Walk Through Notes

Pre Bid: BA 111 Suite Remodel
#2019-0641

December 3, 2018

CASEWORK INT ELEV

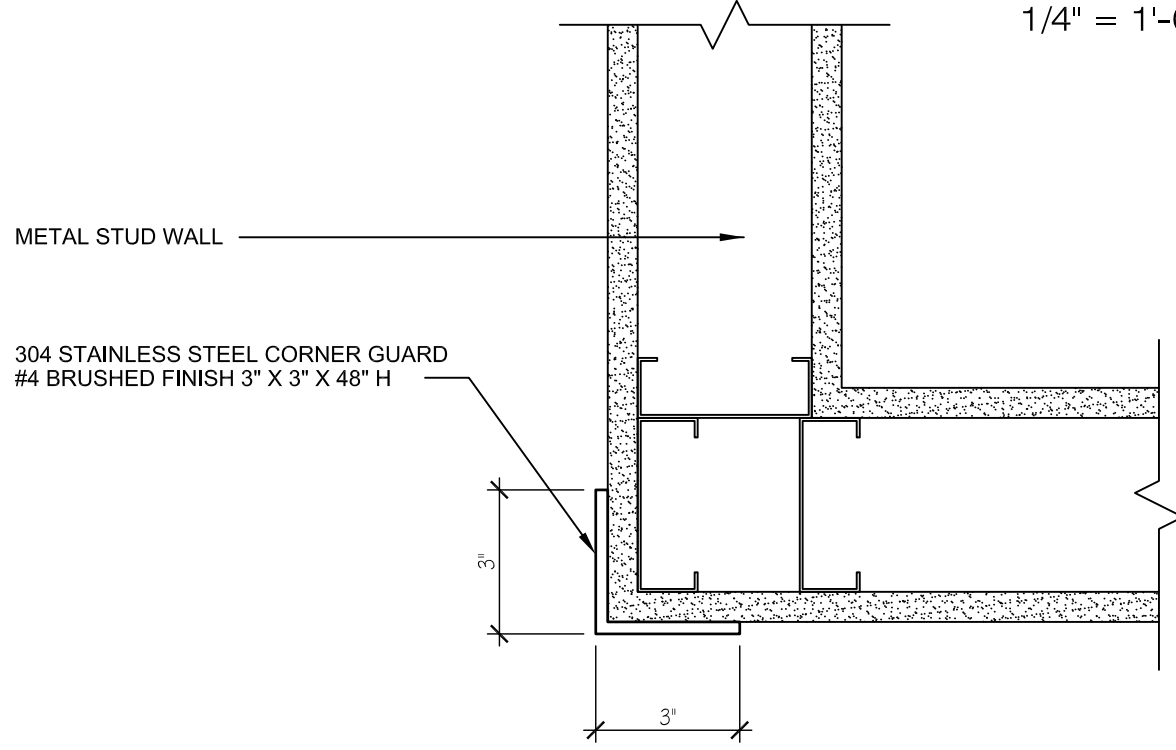
4. Updated Plastic laminate finishes on detail 1/AE501. See the attached revised sheet AE501 revision 1, dated 12/04/2018.
5. There are adequate circuits for the new systems furniture shown.

PLASTIC LAMINATE FINISHES
 COUNTERTOP AND BACKSPLASH:
 WILSONART - OILED SOAPSTONE 4882
 VERTICAL LAMINATE:
 WILSONART - TAN ECHO 7941

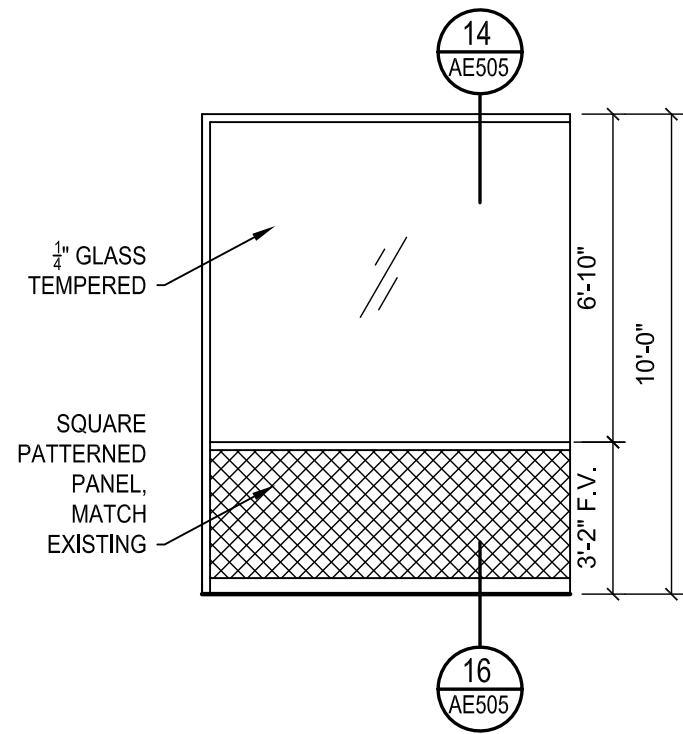
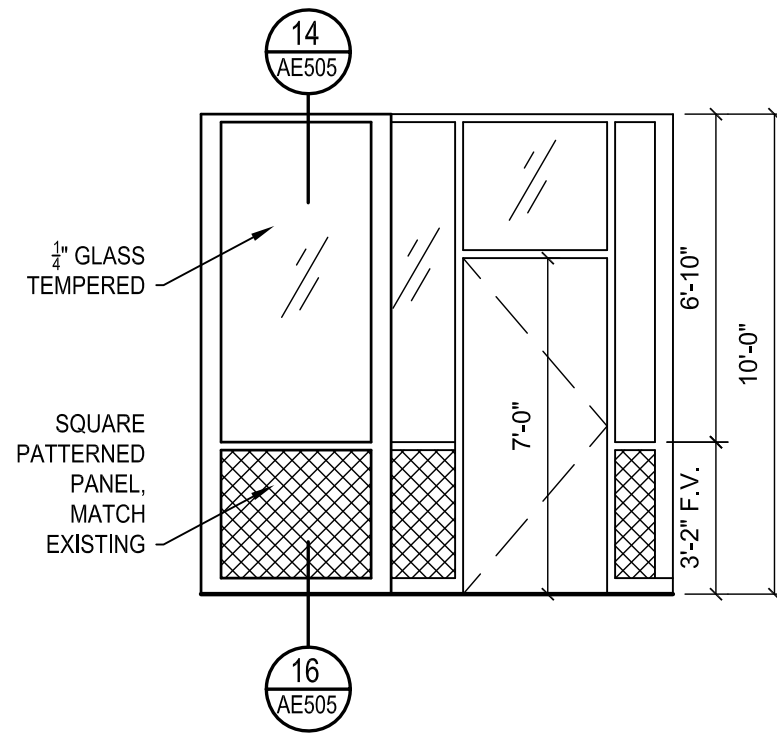
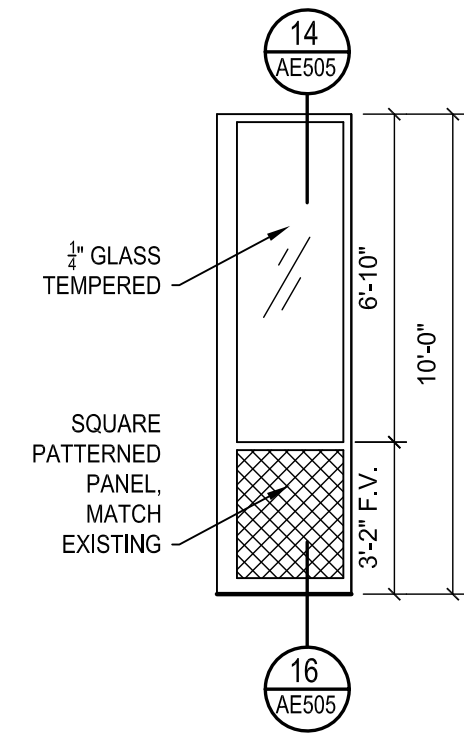
8. See updated sheets AE504 revision 1, dated 12/4/2018 and added sheet AE505.
To clarify, window type 1 is for the west wall in office 111B and 113F, elevation 11/AE504 and it is a hollow metal frame. Window type 2 is for the east wall in office 111A and 111B, elevation 12/AE504, it is also a hollow metal frame. Window type 3 is for reception 113 west wall, elevation 13/AE504 and is a hollow metal frame.
Aluminum storefront systems are for the elevations 8-10/AE504.

M-101

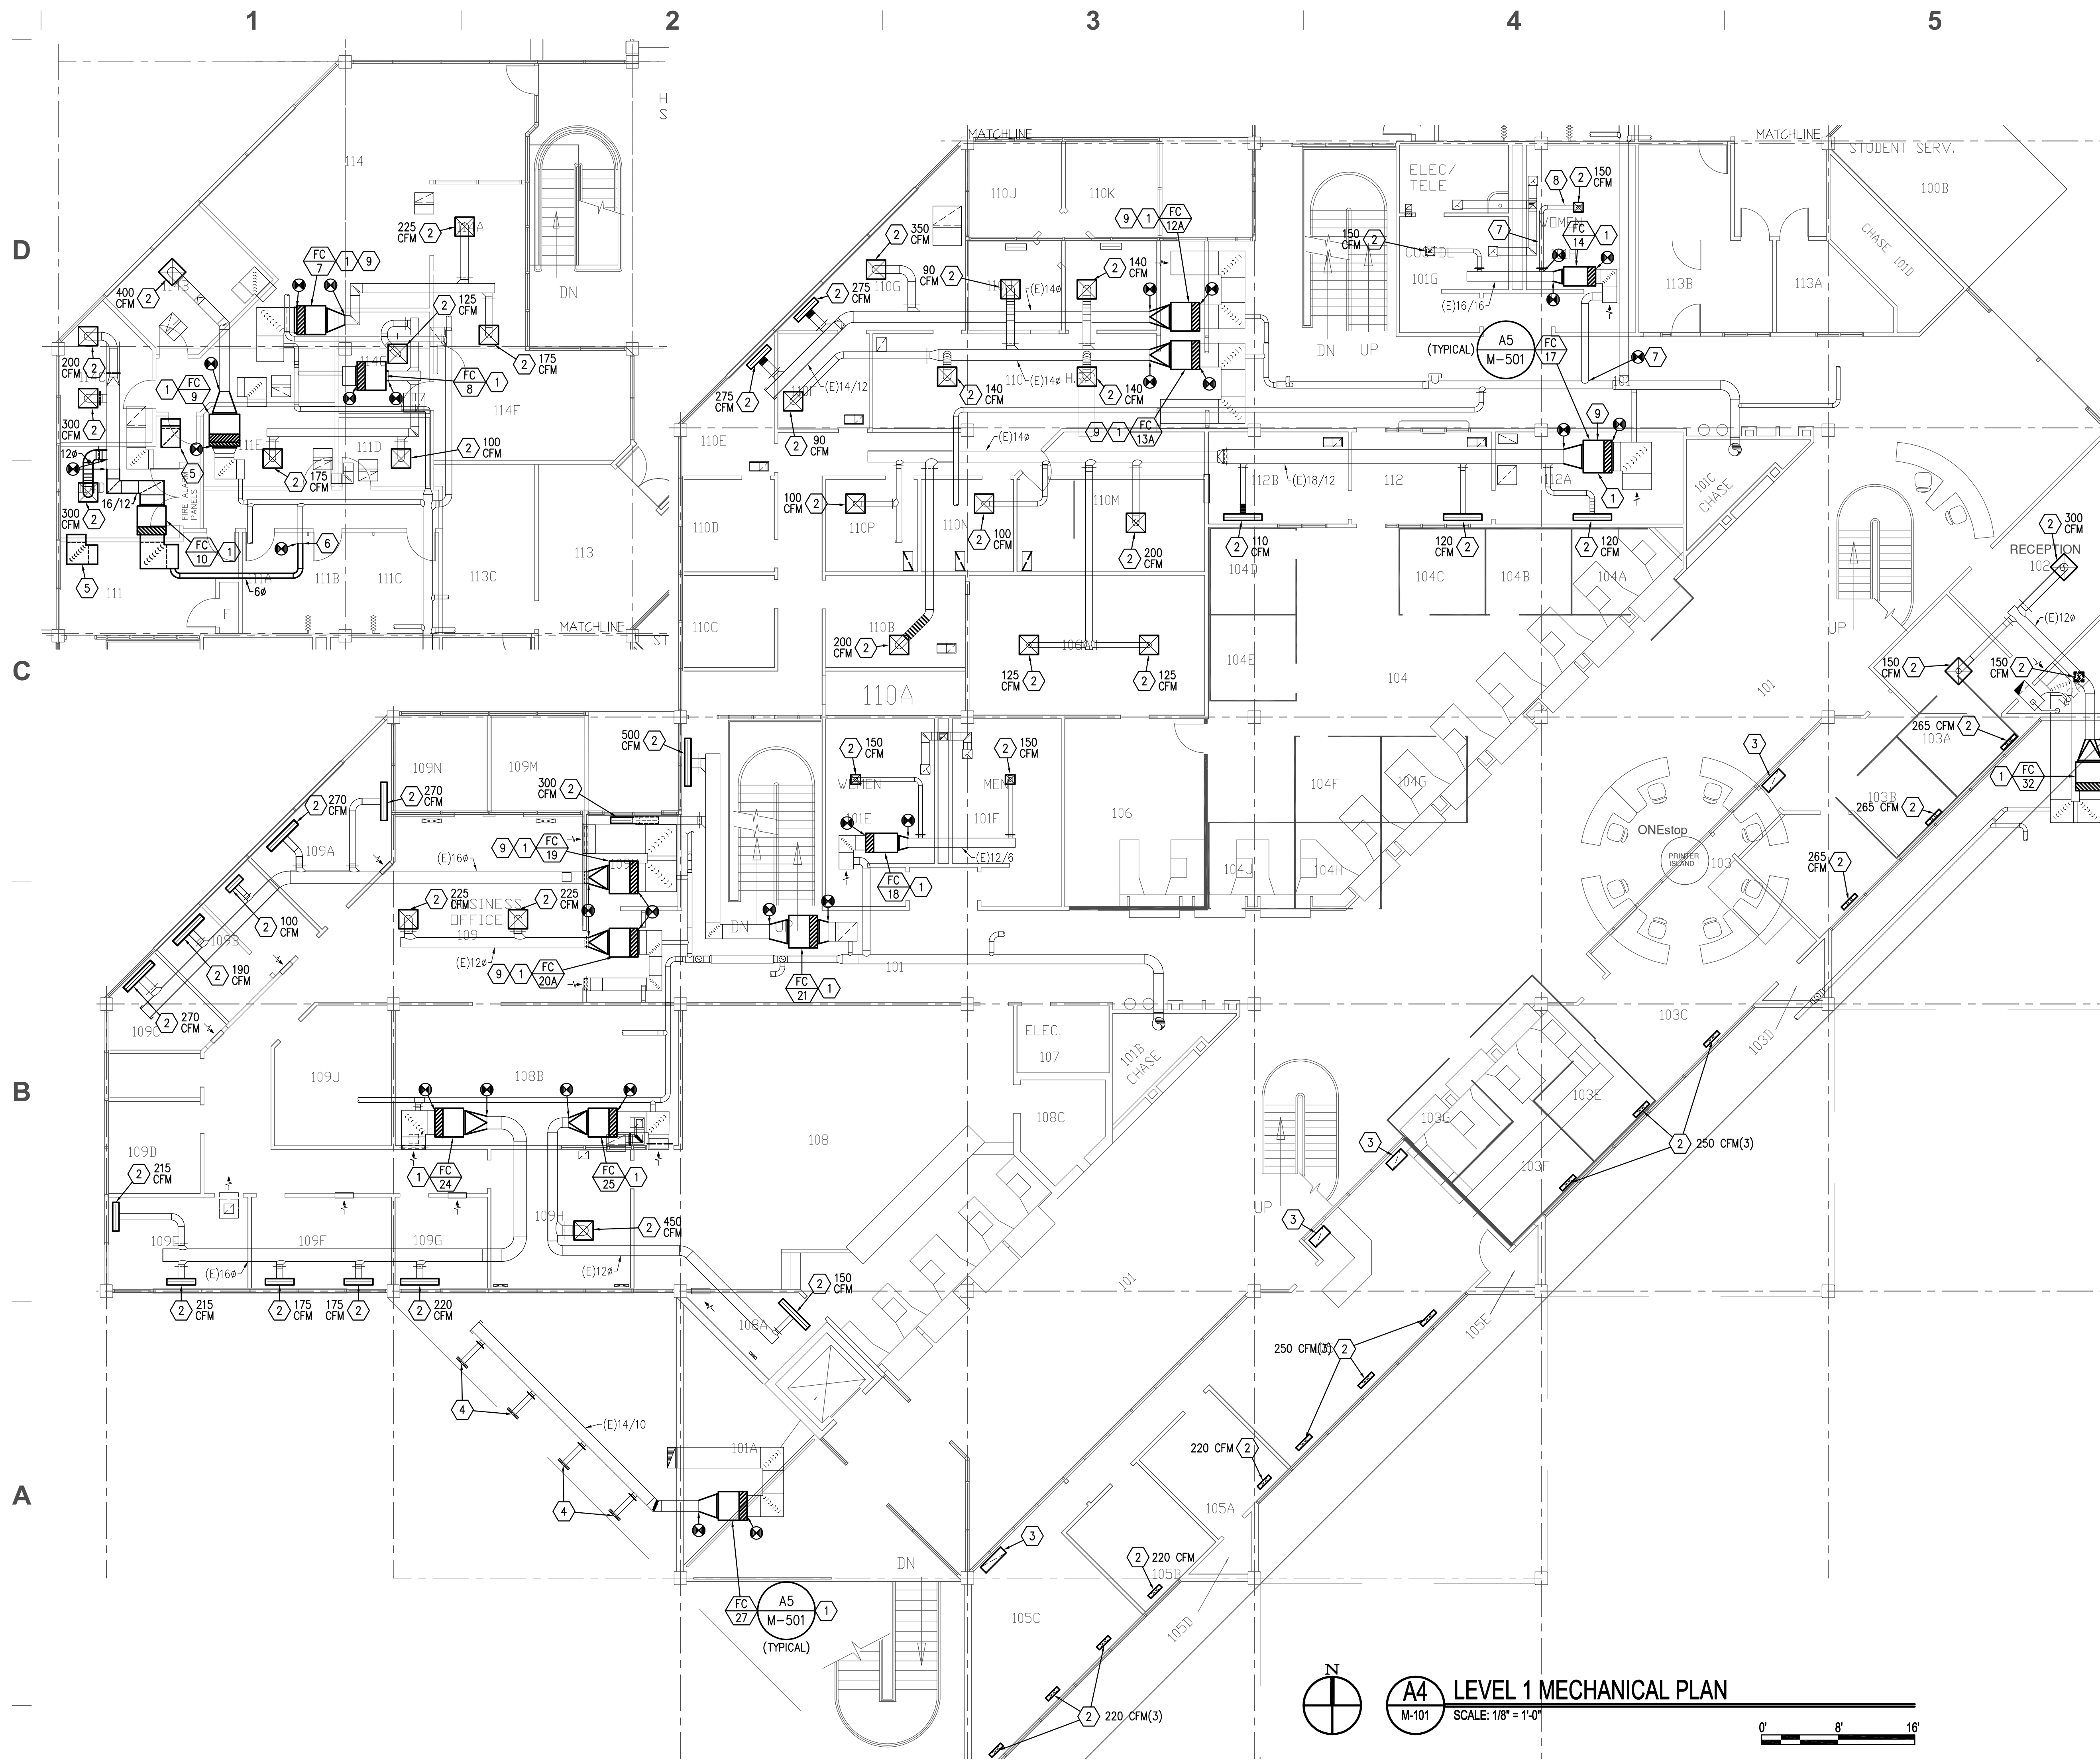
11. Attached is an existing mechanical sheet M-101 of the space for your reference. It shows some of the existing ducts in the space. There is not a new mechanical drawing showing the duct changes.
